Materials Changes for IR Receivers: PCN Update

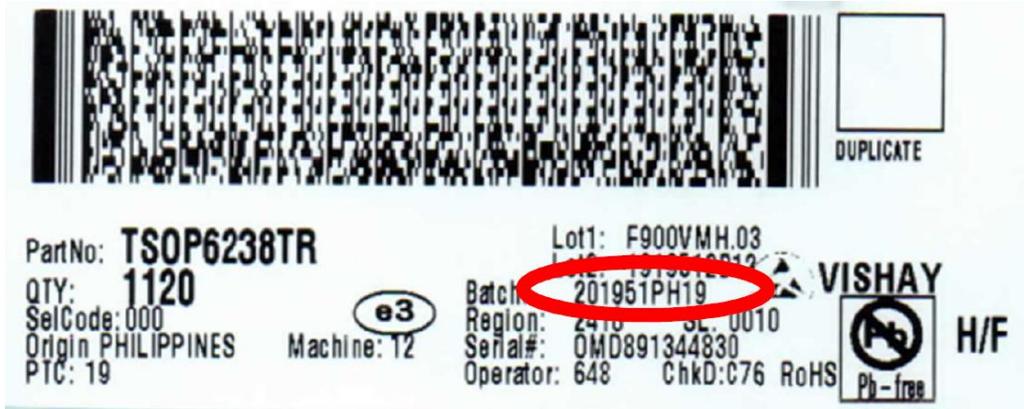
Q: How can the customer distinguish between old and new product?

A: The PCN announces a changeover date. This changeover date will be mentioned on the standard bar code labels as shown below:
